- A. Oaths of Office - Commissioner Chuck Apostolik, Commissioner Mark McDonald, Commission Alternate Bronwyn Rittner, Commissioner Alternate Richard Parks
- B. Brief description of application: Development Sketch Plan 136 Rental Townhomes in 29 Buildings with Clubhouse/Pool

Staff Report

**Castle Valley Ranch PA 8 & 9
Sketch Plan
Planning Commission – June 8th, 2022**

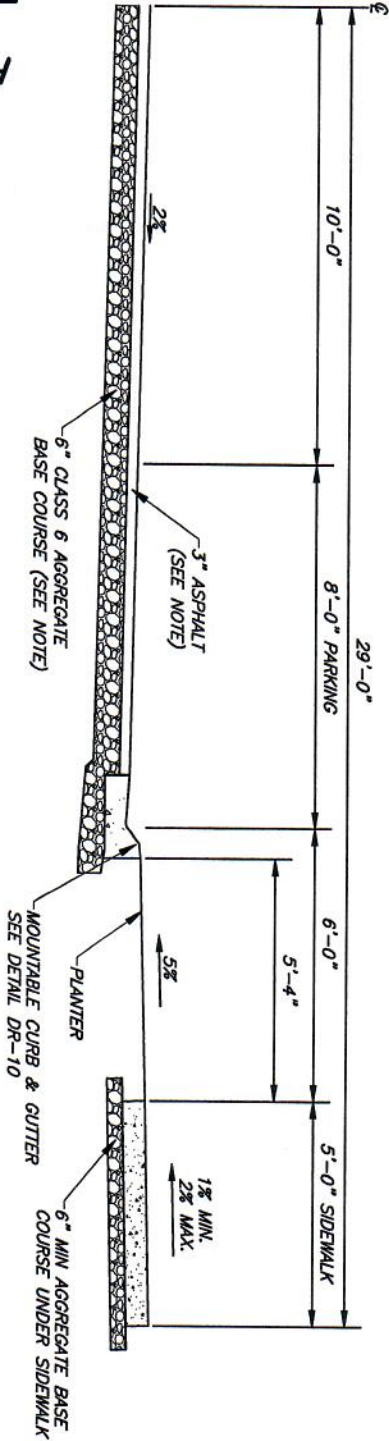
The fire Hydrant manufacturer is not listed. Fire hydrants must be Kennedy K-81.

UPDATED MASTER PLAN MAP CASTLE VALLEY RANCH

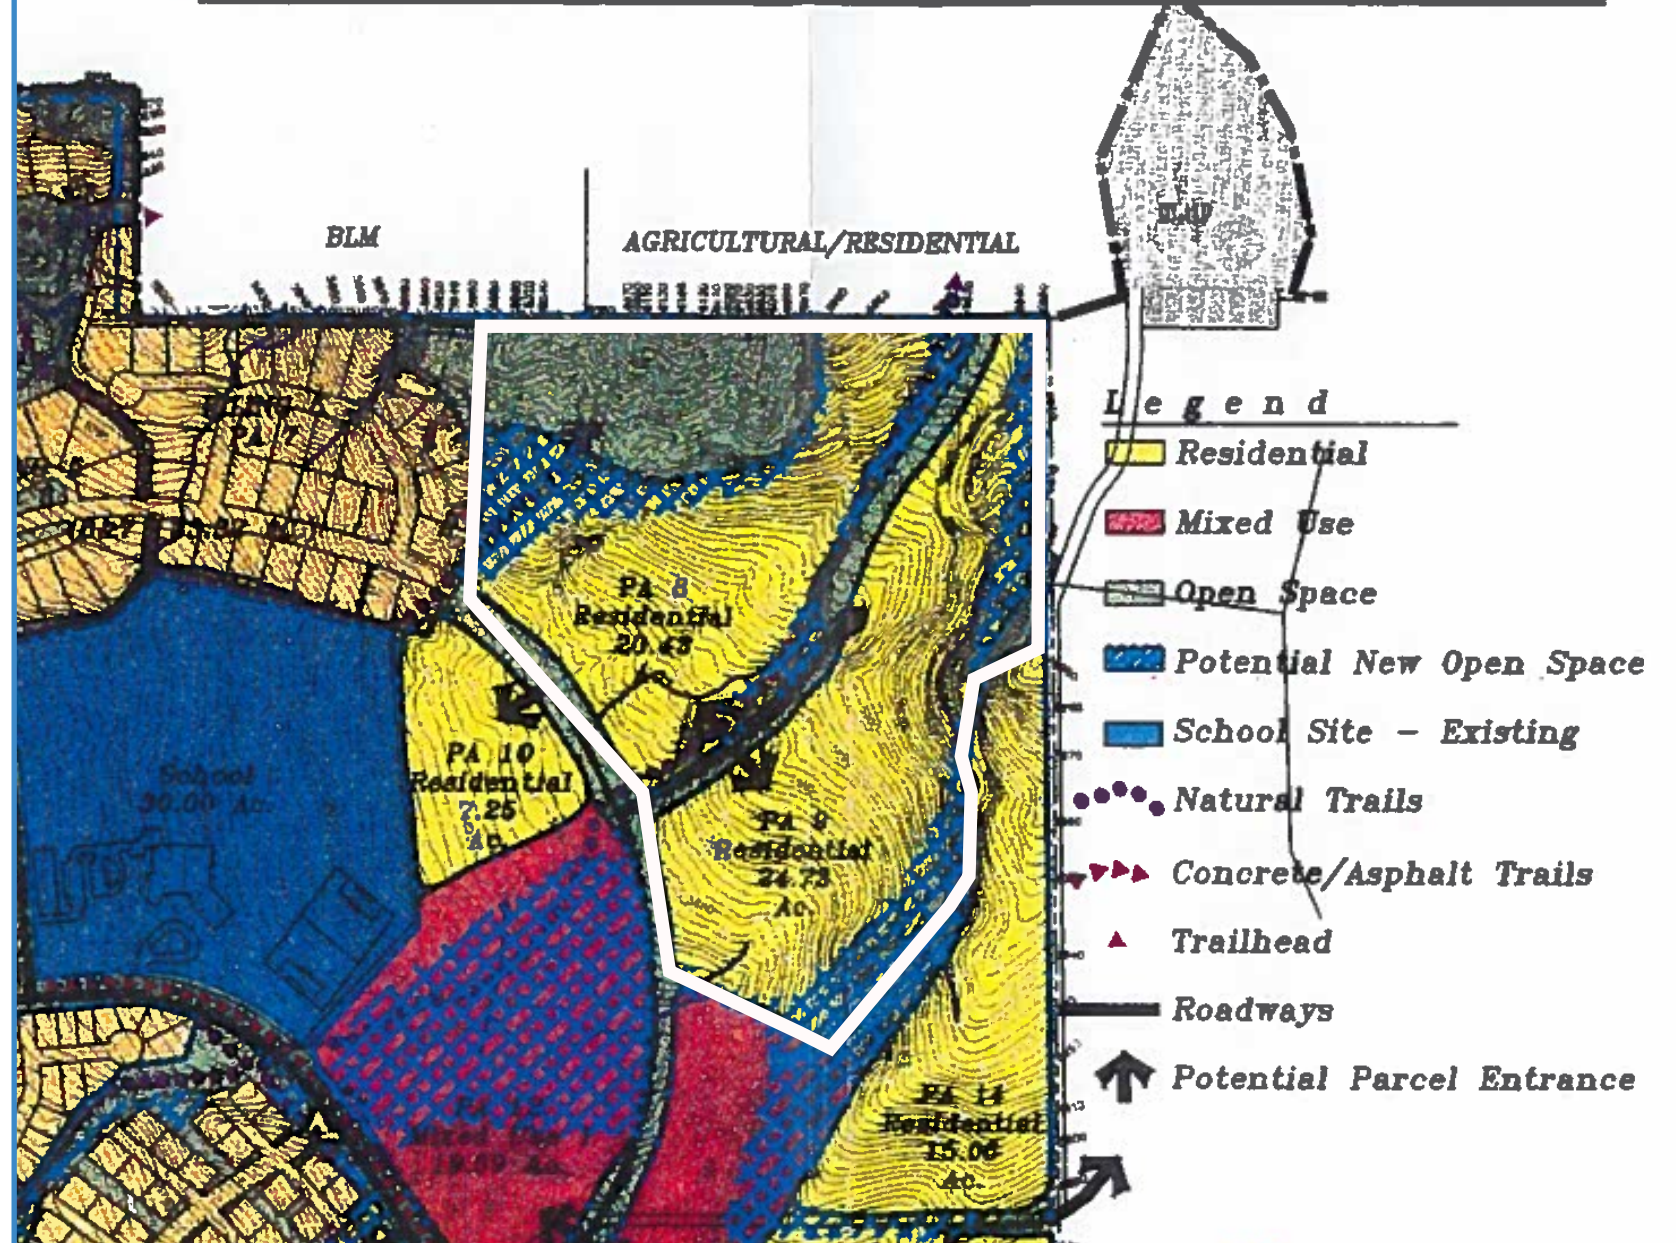
Streets: Per comment from the Public Works Director, the town contemplates maintenance of all future streets once all public improvements are approved. At dead end streets, cul-de-sacs are also recommended in lieu of T-turnarounds. Exhibit C shows a recommended ROW design of 58 feet in contrast to a 50 foot proposed design (page 12).

7. Within the subdivision, streets will need to be designed to follow the street standards outlined by the Public Works Director, complete with snow storage. Provide a cul-de-sac at the dead end streets in lieu of the tee turnaround proposed.

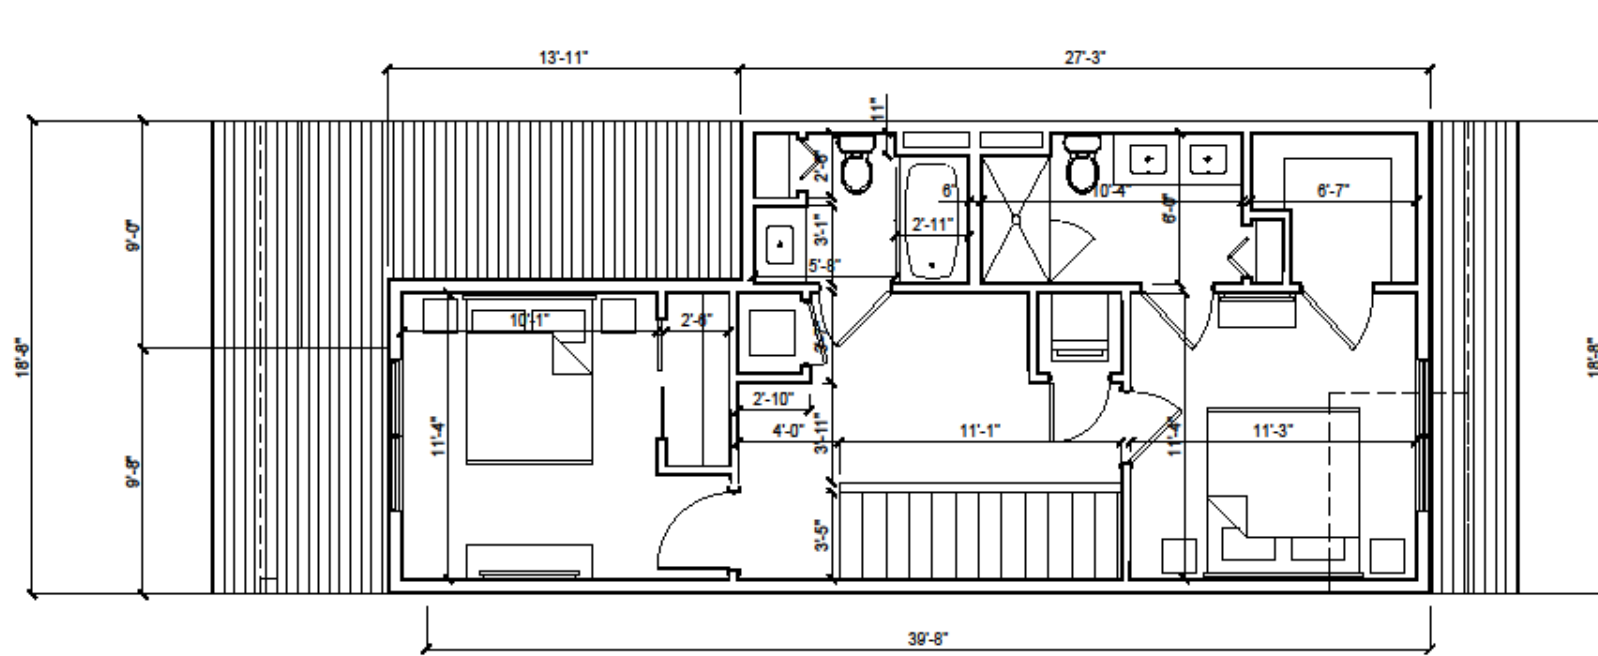
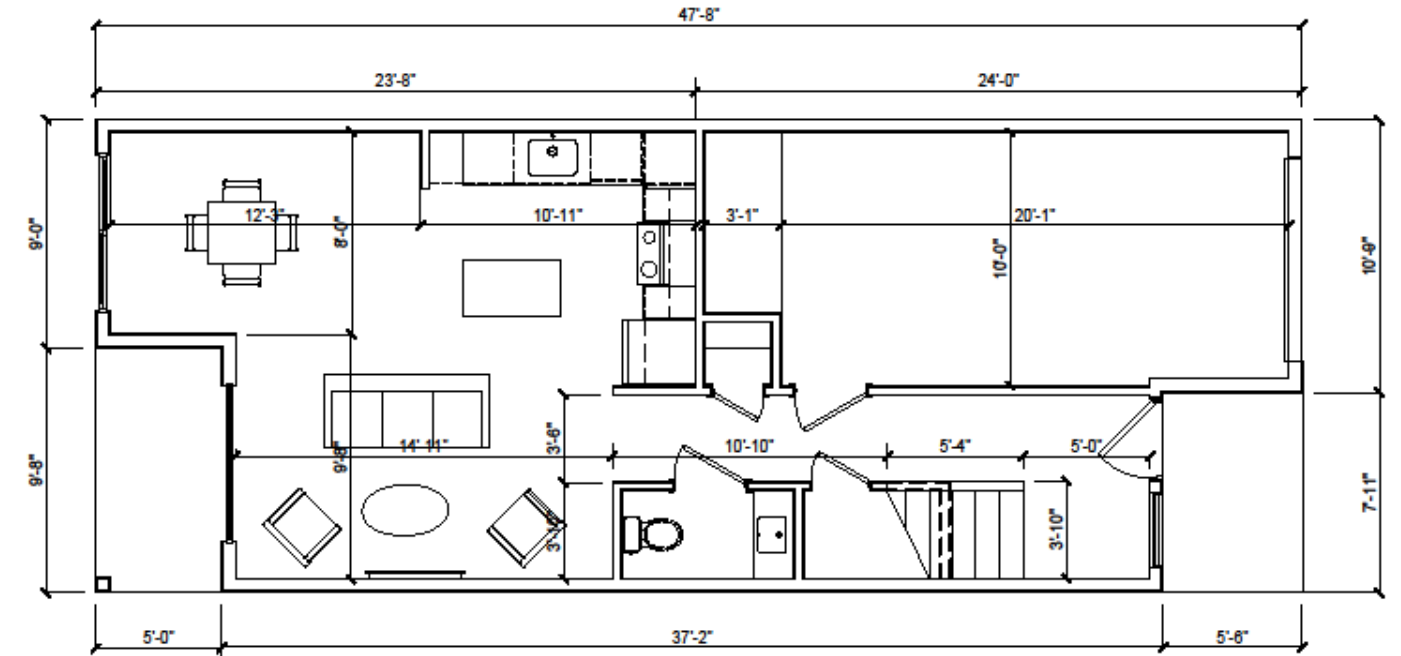
- 1) *Dimensional Standards: Indicate building heights on the elevations.* We have added the second set of building elevations to the package to illustrate variety in building materials; building elevations are now pages 13 and 14 of the set. A note has been added to each describing the current max building height (28'-4") and the maximum allowable height per MF-1 (35'). Please note that the elevations do not represent each of the building types.
